# Report Of Accessibility Audit of the Incubation center and Criminology Newly Constructed Building at the University of Peshawar

On the day of 09<sup>th</sup> of November, 2021, FoP Collaboratory with Community services Program (CSP) conducted Accessibility Audit of the Newly Constructed Building at the University of Peshawar, Khyber Pakhtunkhwa. The Audit convened academicians, University of Peshawar administration, media, and Friends of Paraplegics team. The Accessibility Audit Surged University of Peshawar on the Higher Education of Pakistan (HEC)'s policy for Students with Disability 2021 which aims to create an enabling environment Education Sector to not only motivate students with disabilities to undertake higher education, but also facilitates their participation in all academic and extra-curricular aspects of a university education. Accessibility checks of the IC and criminology department building and identify the spots where they can improve access and maximum participation of PwDs students. On this occasion, Professor Dr. Muhammad Idrees, Vice Chancellor, University of Peshawar, Project Director Prof. Dr. Yorid Ahsan Zia, Dr. Shakeel Ahmed, Director, Community Service

**Figure 1.1. Accessible Washroom Measurement**

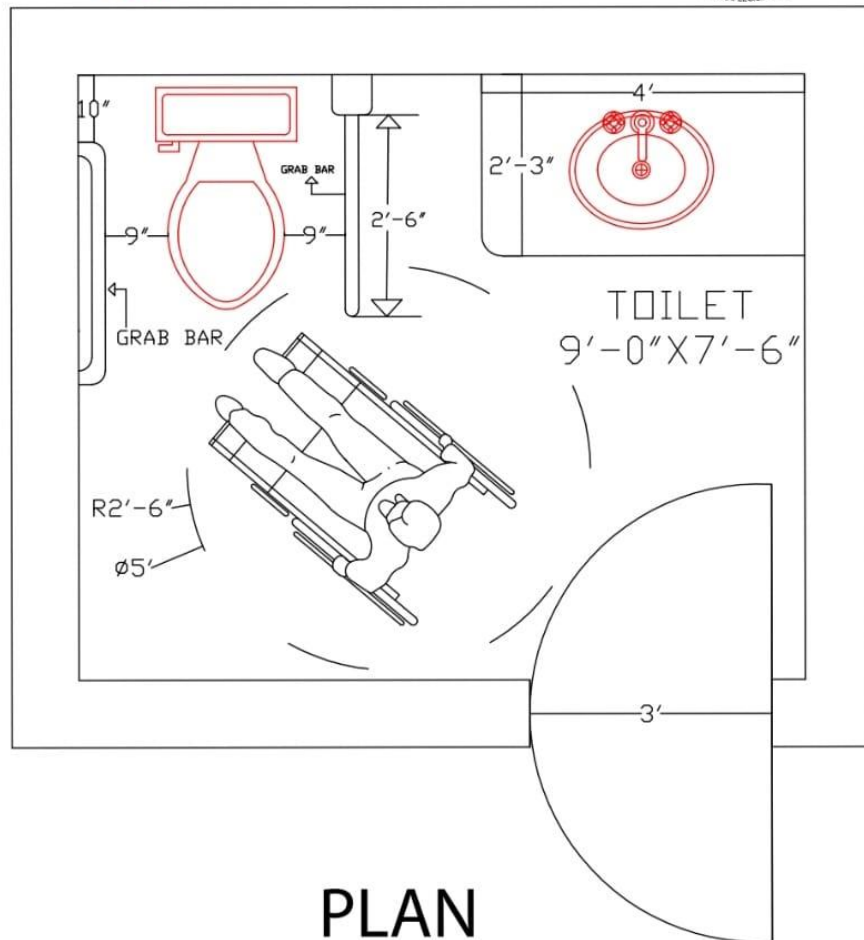
- ❑ Stay after the ramp of IC was not up to the standard and we recommended to increase that stay up to 6feet to avoid injury.
- ❑ Grab bar in washroom of IC were missing which is important for sever students and staff with disabilities.

- ❑ The mirror height were more than 3 feet and recommended to decrease its size so wheelchair user will be able to use it.
- ❑ Height of the toilet and turning area was good and they have 1 reserve washroom for PwDs.

- ❑ No reserve parking was found and no signage were in the parking for reserve parking
- ❑ Washbasin was also not accessible and the clear area length for good but feet were not as per standard of 18 inch and in basin lever handle were recommended

Image 1.1. *Measurement of Ramp walk*

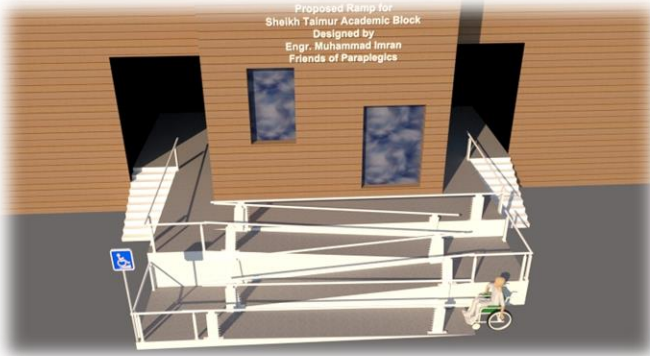
- ❑ Incubation center ramp height was 56 inch and run were 45 feet which were less than 1 ratio 12 but it's acceptable, as per standard it was required 57.6 feet.

- ☐ Ramp height was 50 inch and length was 43 feet and it was less than the standard of 1 ratio 12, it was required 50.4 but its run is 43 feet with the ratio of 10.23 which is less than 1 ratio 12 but it acceptable
